ADDENDUM 2

Vestavia Hill Fire Station No. 4 Expansion

DATE: **August 12, 2026**

2 BUILDING SECTION

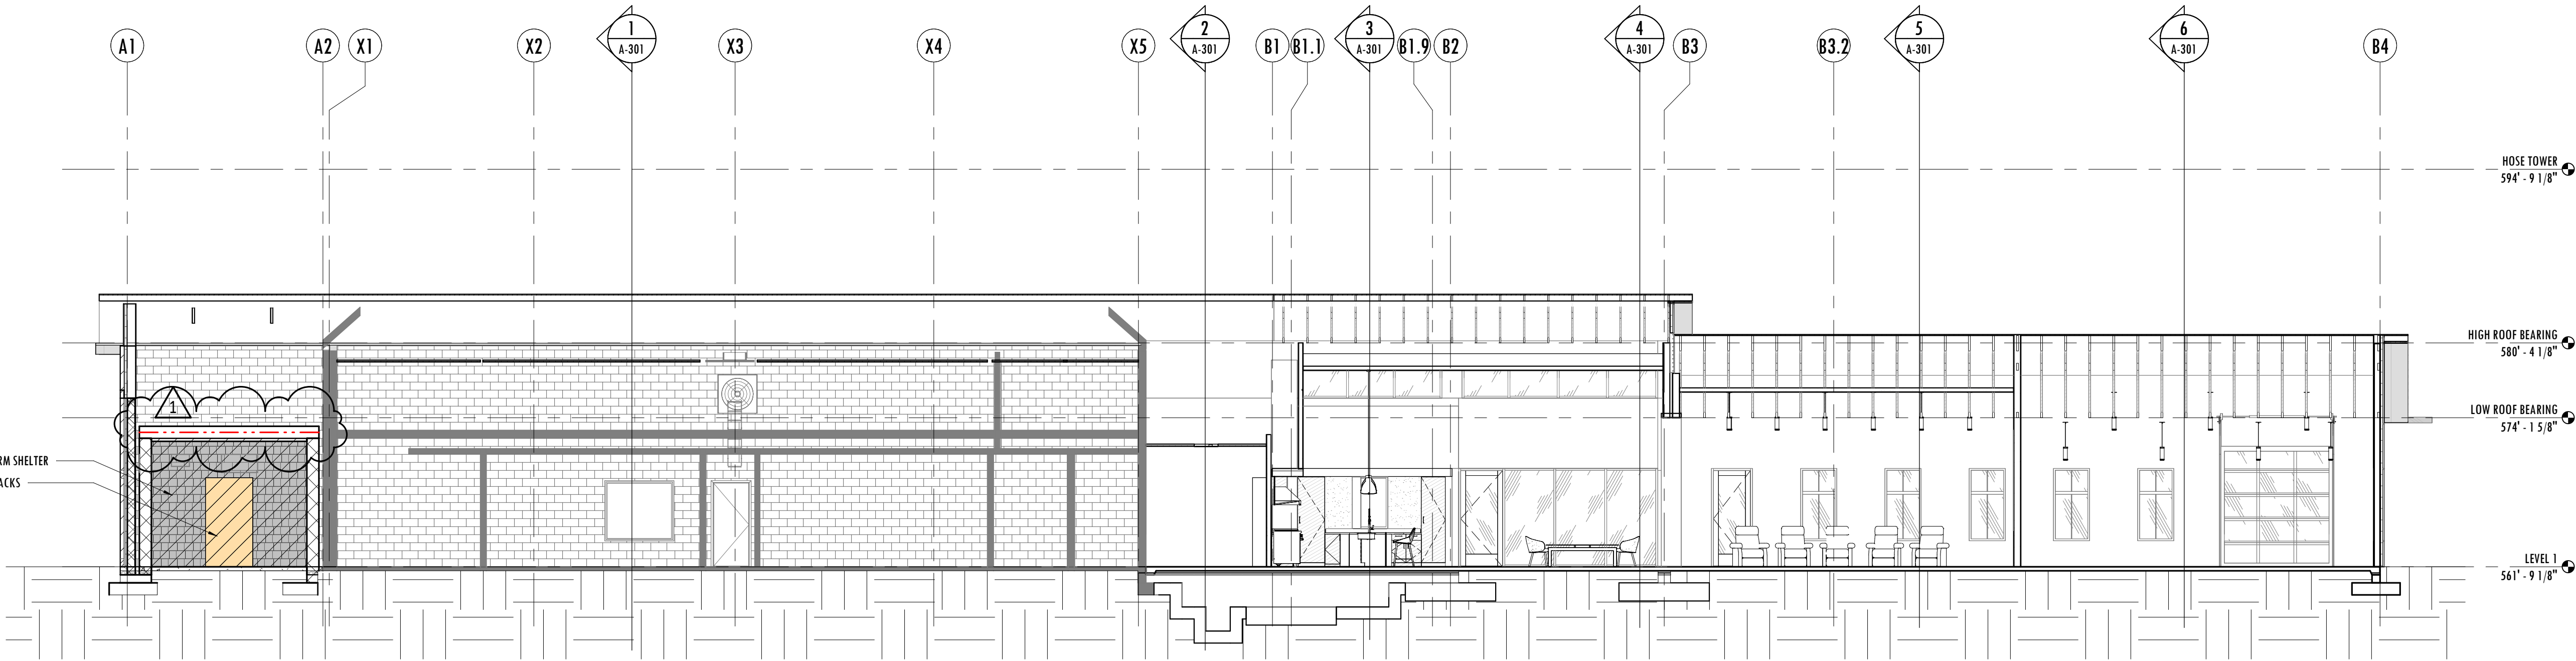
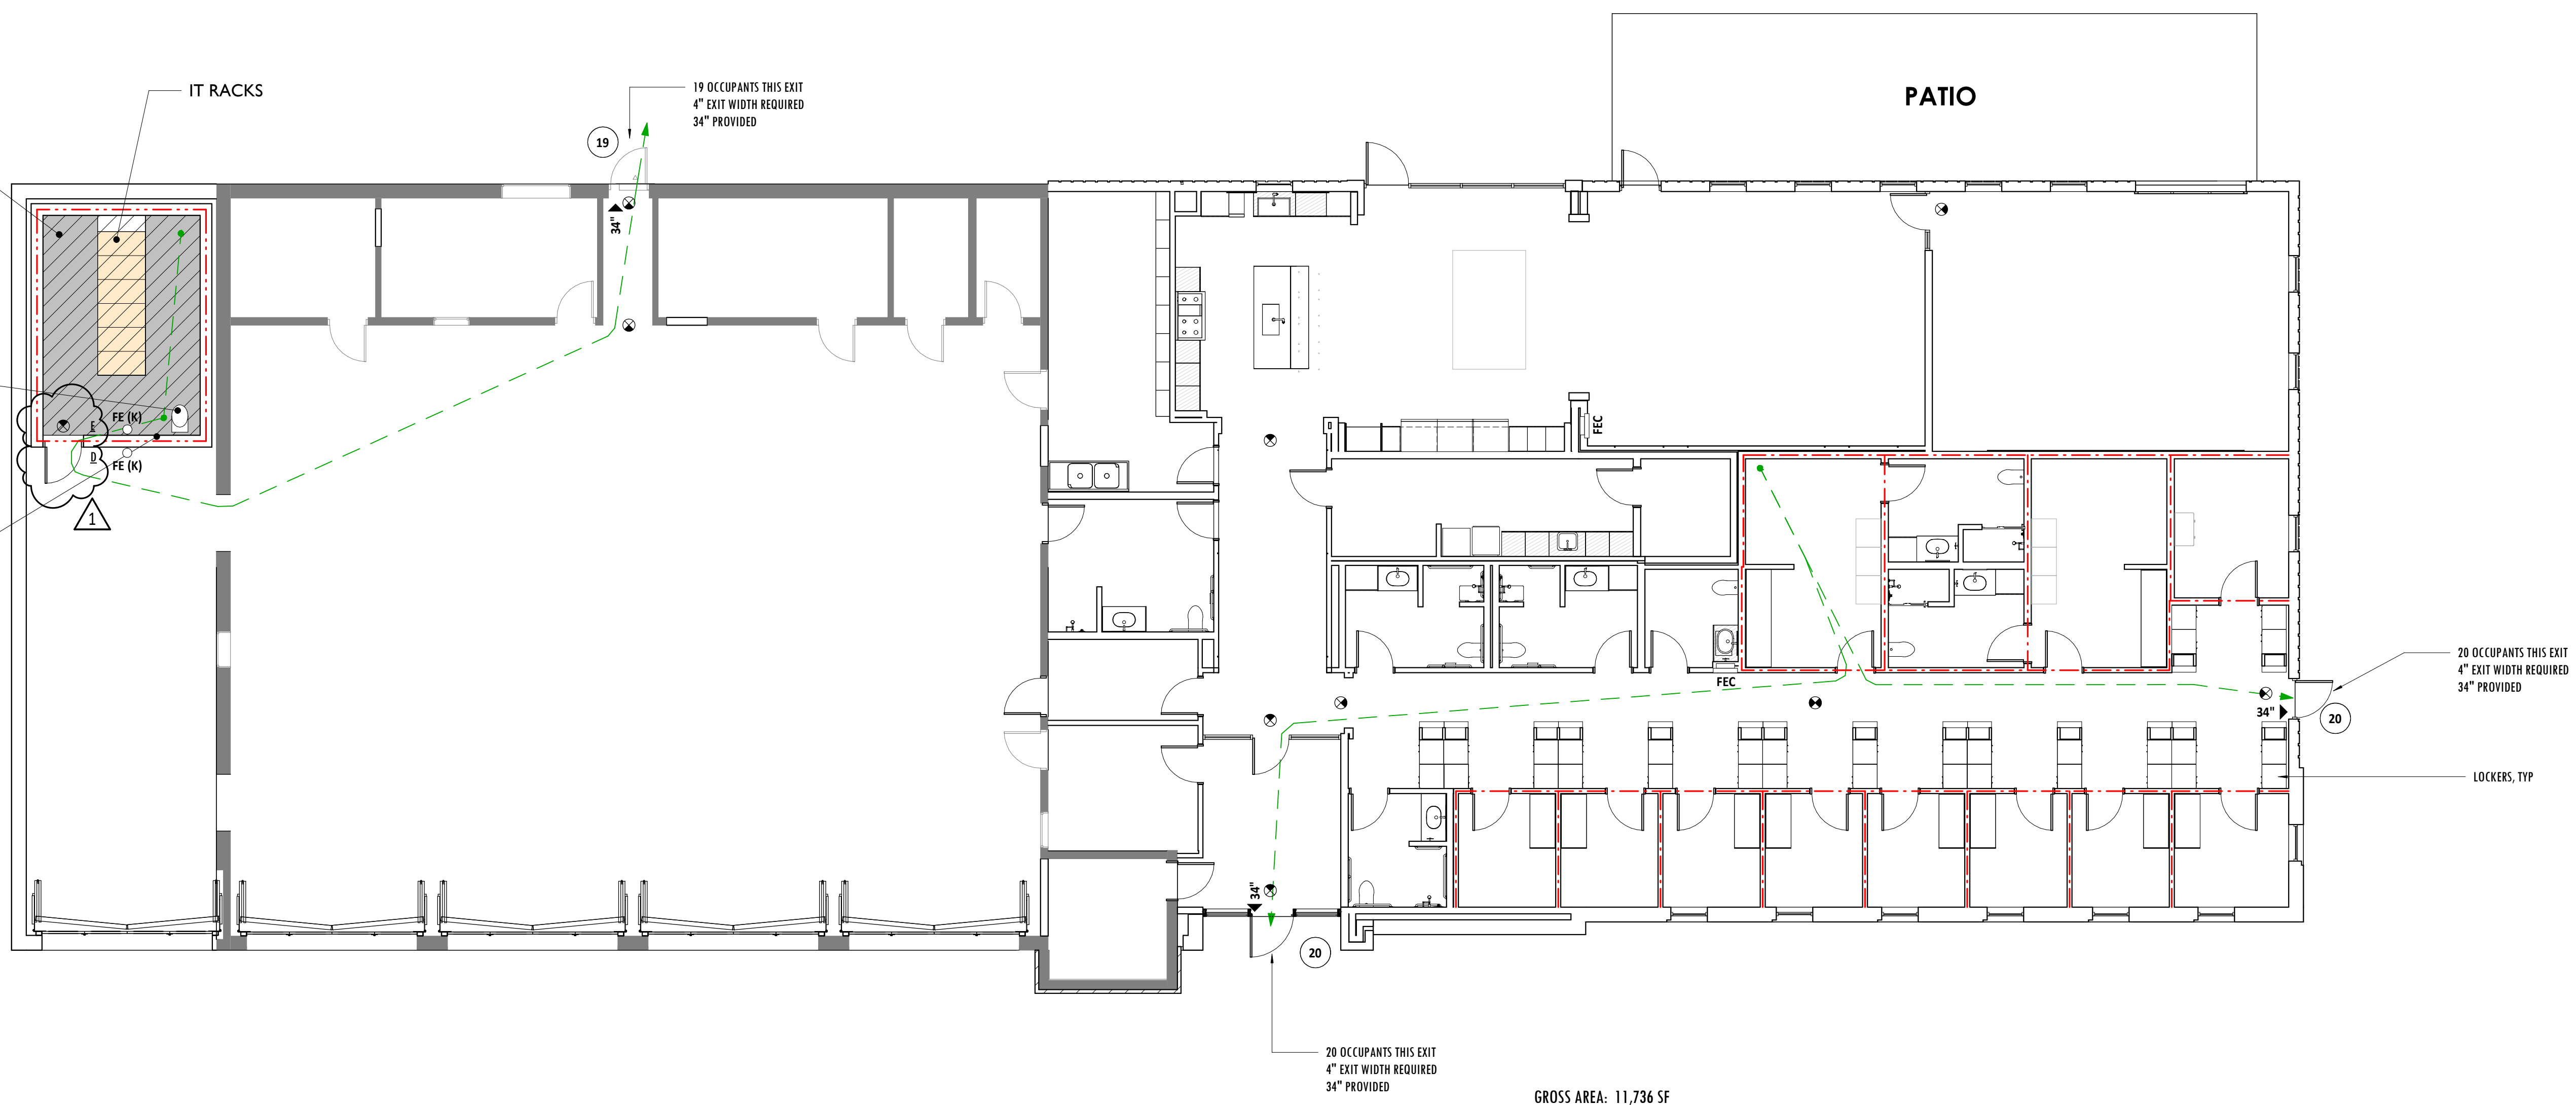
- b. Drawing 2/LS102: Two-hour rating shown for ceiling/deck assembly at Storm Shelter for clarification
 - c. Storm Shelter door 130A has been revised to swing out. See revision clouds.

LS102

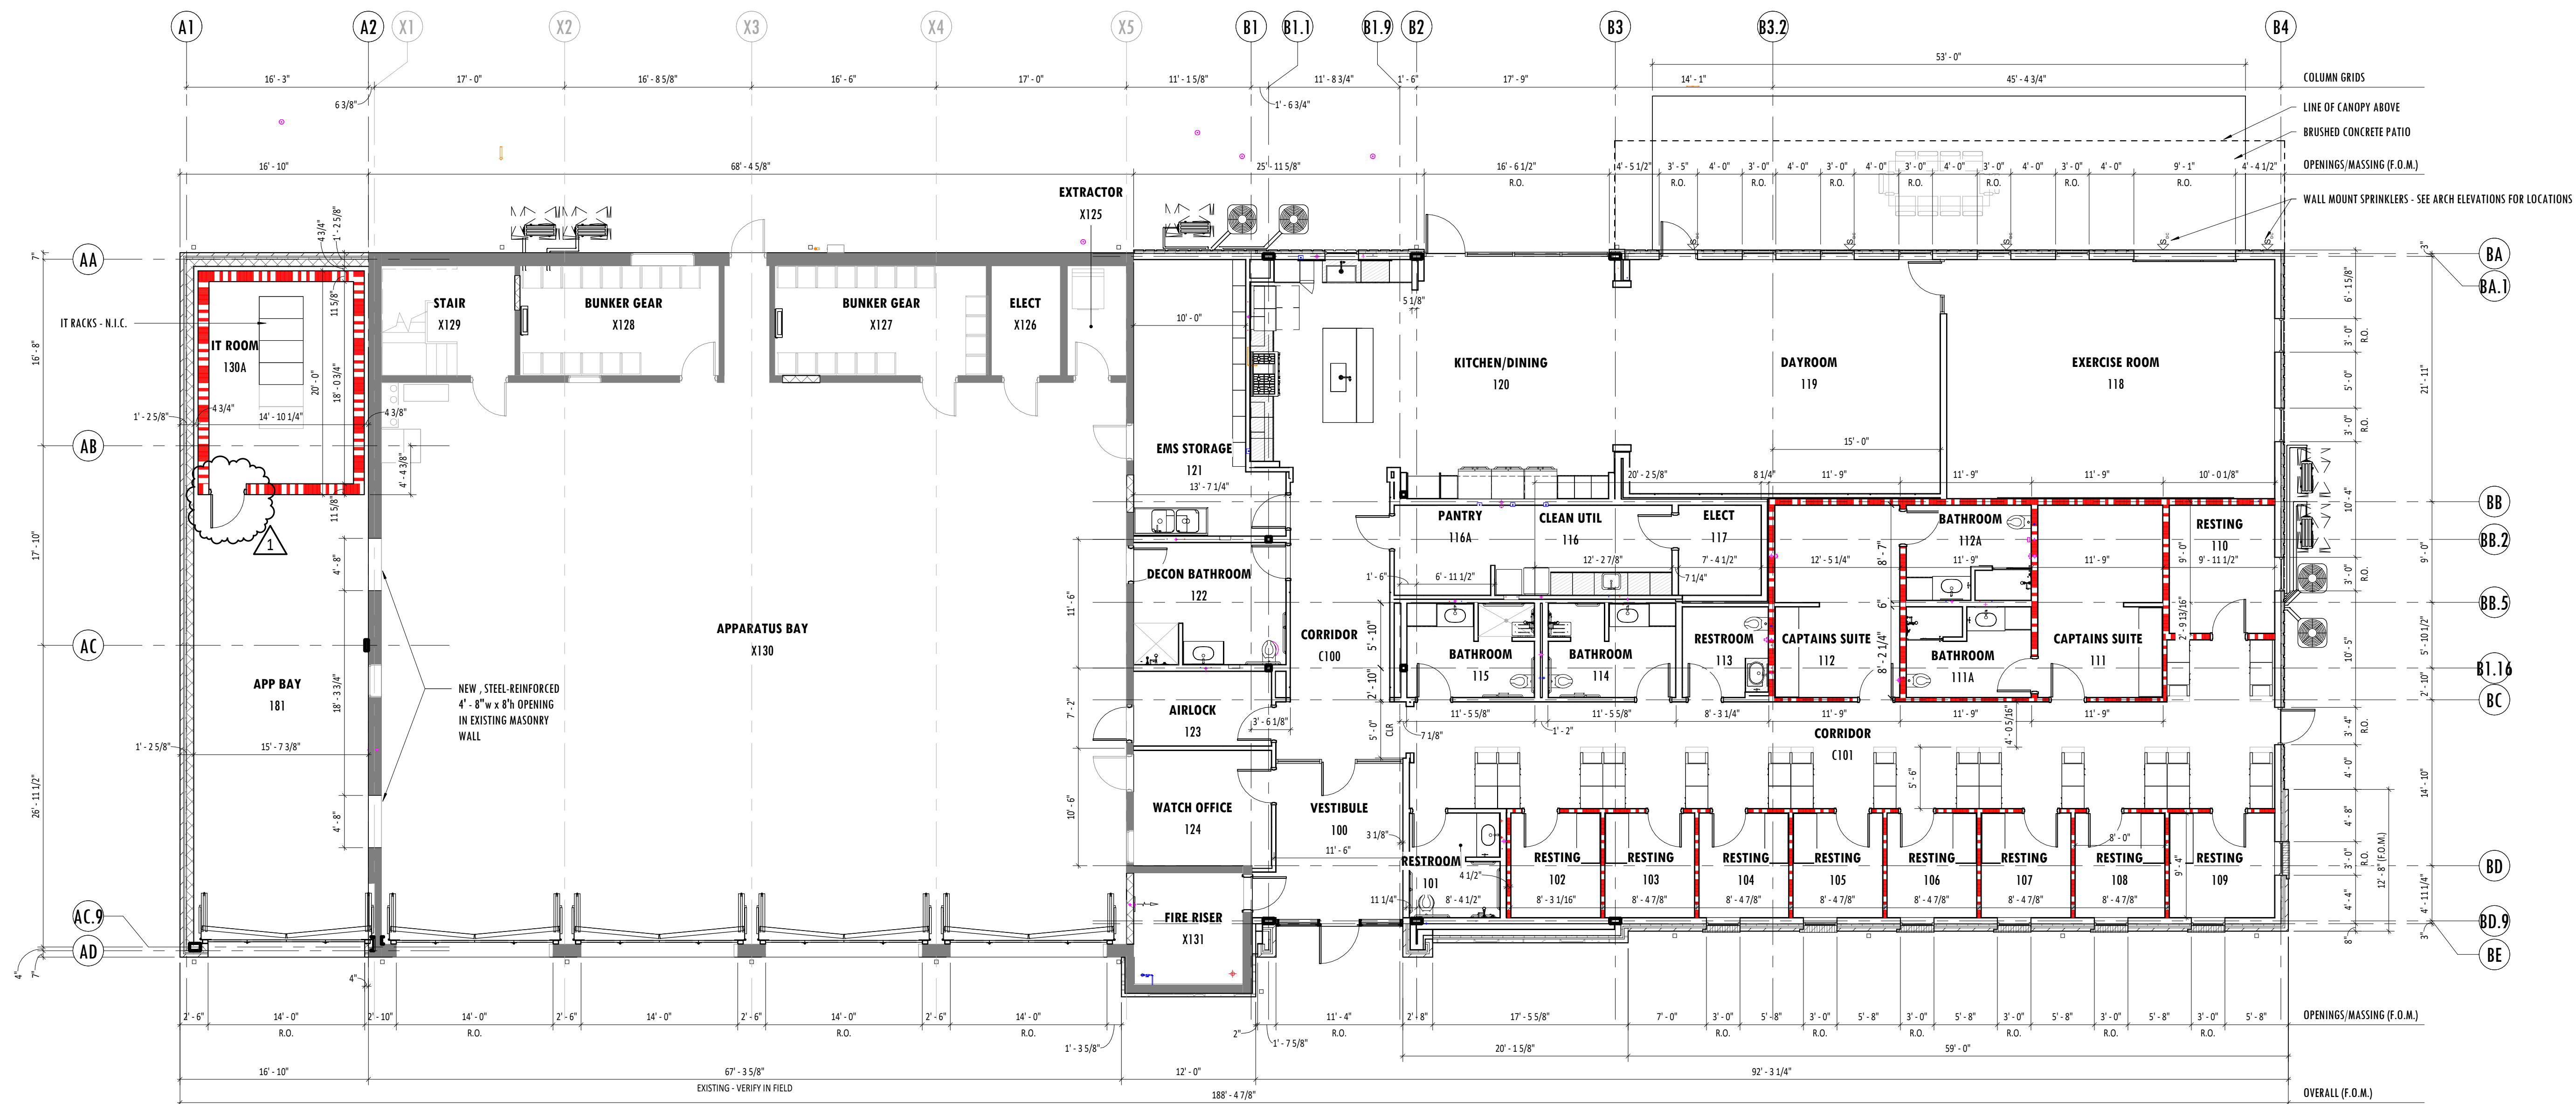
- a. General Note, “ALL PENETRATIONS 2" OR GREATER MUST BE BAFFLED TO PREVENT INTRUSION OF DEBRIS DURING A STORM EVENT.” added to Storm Shelter Requirements
